From: Jessica L. Titel
Sent: Friday, August 25, 2023 3:55 PM
To: Patrick Hayden; Kara J. Homan
Subject: RE: Rezoning Concerns
Attachments: Alderperson Hayden Responses - 4th Adn Clearwater Creek.pdf

Questions from Alderperson Hayden

4th Addition to Clearwater Creek – Rezoning and Preliminary Plat

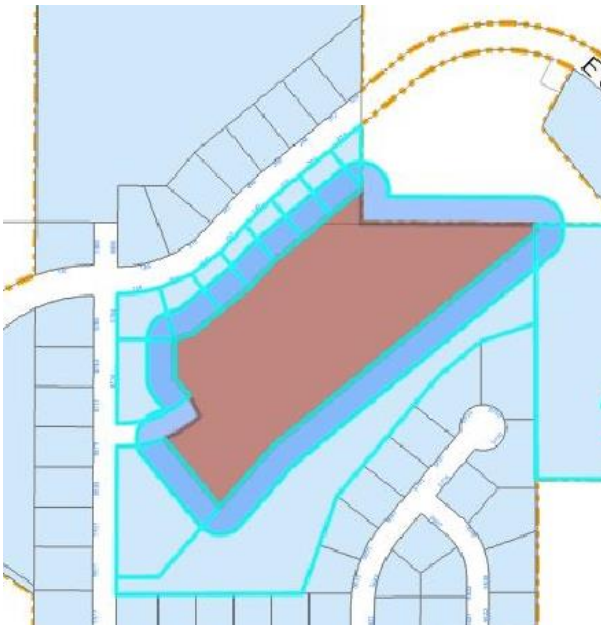
- We've gotten answers around park development in previous conversations. One concern is getting to Plamann Park. Is there any way to make getting across the road safer for the community since there is no park for residents in their neighborhood?

Safer crossings are reviewed at the time of trail or roadway construction/re-construction. No near future plans for trail development to Plamann Park. The trails master plan shows future bike lanes and trails on Meade and Broadway but there is nothing planed at this time. The City is slowly working on a trail connection off Broadway heading north on Kurey and going NE to Ballard/Applecreek. But this is just being mapped at this point, no timeline for construction.
